SKI Rapport 2008:15

International Expert Review of Sr-Can: Safety Assessment Methodology

*External review contribution in support of
SSI's and SKI's review of SR-Can*

Appendix 4: Questions by the Safety Assessment Methodology Review Team Before the Hearing and SKB's Answers

Figure 1. Dose from releases to geosphere for different canister thicknesses. 1,000 realizations of each case, analytical model.

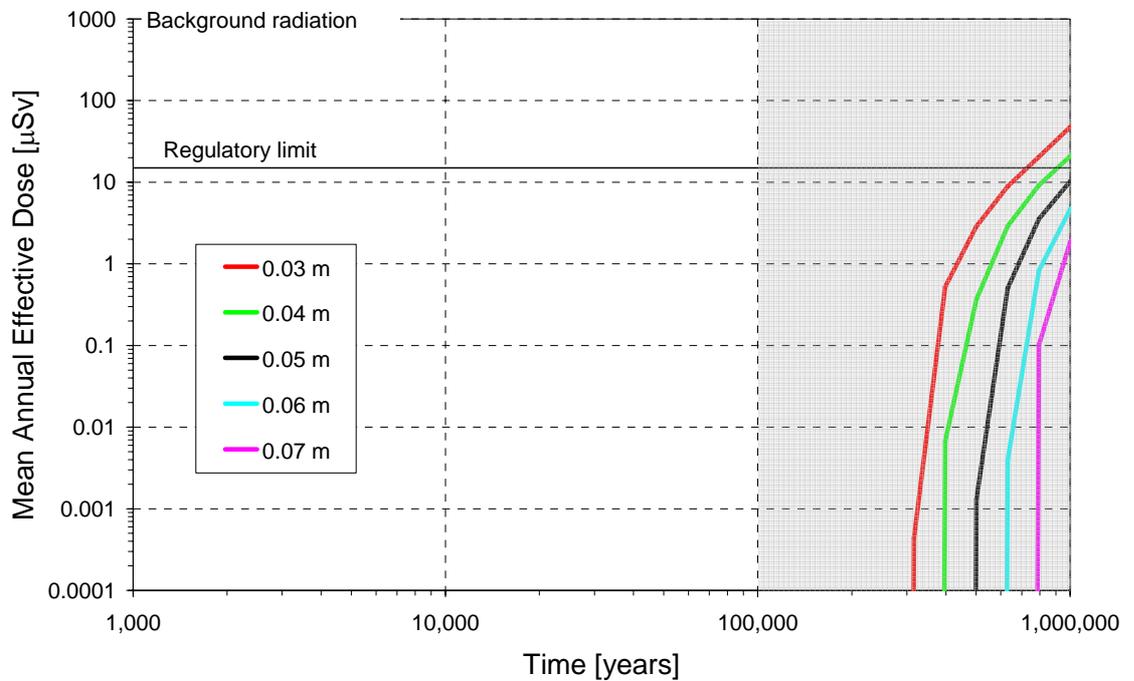
59.	<p>Has SKB carried out any simple sensitivity analyses for the Safety Functions? Those presented in Section 10 do not address the safety functions directly, or at least are hard to interpret. Consequently, Section 13 contains many unsupported assertions that would be easier to judge if there were diagrams showing, for example, sensitivity of calculated risk to canister thickness, buffer function longevity, number of canisters failed, etc. Can SKB show any information of this type?</p> <p>Sensitivity to canister thickness was not calculated in SR-Can, but can readily be done using the expressions in Appendix B to the main report. This has now been carried out and the result is shown in Figure 1 below. The figure shows the effect of varying the canister thickness around the reference value of 0.05 m for the Forsmark advection base</p>

case (Figure 10-42 in the main report). The risk contribution from the advection/corrosion scenario (not calculated here) is expected to vary in a similar manner. Note that no other consequences of an altered canister thickness (possibility of handling the canister at all stages prior to deposition, defect distribution when welding a different thickness, etc) have been looked into.

Sensitivity to buffer longevity has been bracketed by the three cases considered: Immediate loss of buffer, buffer loss according to the crude Qeq-model and no buffer loss. As discussed in chapter 13 and elsewhere, the two former assumptions yield almost identical results, whereas the third implies that the risk contribution from the advection/corrosion scenario vanishes.

Figure 2. SRRC results for rock transmission at Forsmark.

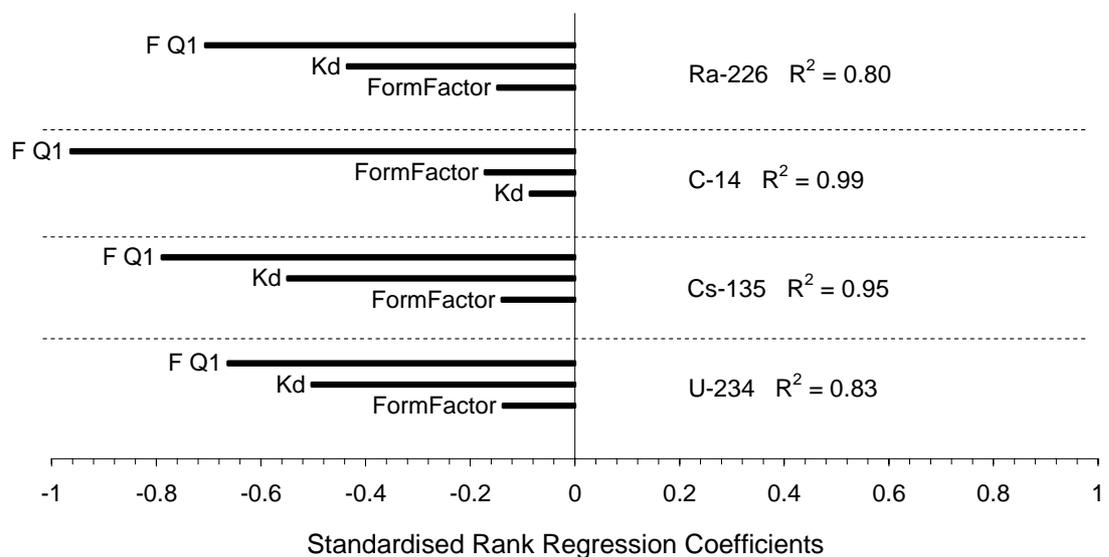
In any case, it would be helpful to receive a more elaborate explanation of the results presented in 10.5.9 and of the lessons that can be learned from them.

These sensitivity analyses were left out due to time constraints and since they are not expected to provide appreciable new information in relation to the Interim report. (No, the quoted sentence is not an obsolete relict from the Interim report, but it should really read “discussed in section 10.5.10” rather than “used in section 10.5.4”. The text referred to was originally part of section 10.5.4 and then moved to 10.5.10. Unfortunately, the reference was not updated.) Some SRRC-analyses have now been done and the ones for the transmission calculations for Forsmark are given in Figure 2 below. The results are quite similar to those in the Interim report in that uncertainty/variability of the F-factor of the rock has the highest influence on output uncertainty, followed by the Kd-value of the nuclide in question or the Formation factor (which expresses the uncertainty/variability of the effective diffusivity in the rock, see table 10-3 of the Main report and further the Data report, section 6.7). Further SRRC-results are given in the answer to OVERSITE question 4.

Lessons learned from the results in section 10.5.9: The Figures in section 10.5.9 show the distribution of geosphere transmissions over the ensemble of deposition holes at the two sites. The Figures demonstrate that a considerable fraction of the deposition holes (around 62% and 52% for Forsmark and Laxemar, respectively) are either not intersected by the fracture network, or intersected by fractures associated with such transport conditions that a release through this fracture never reaches the surface. (This is evident already from the hydrogeological analyses in section 9.3.6.)
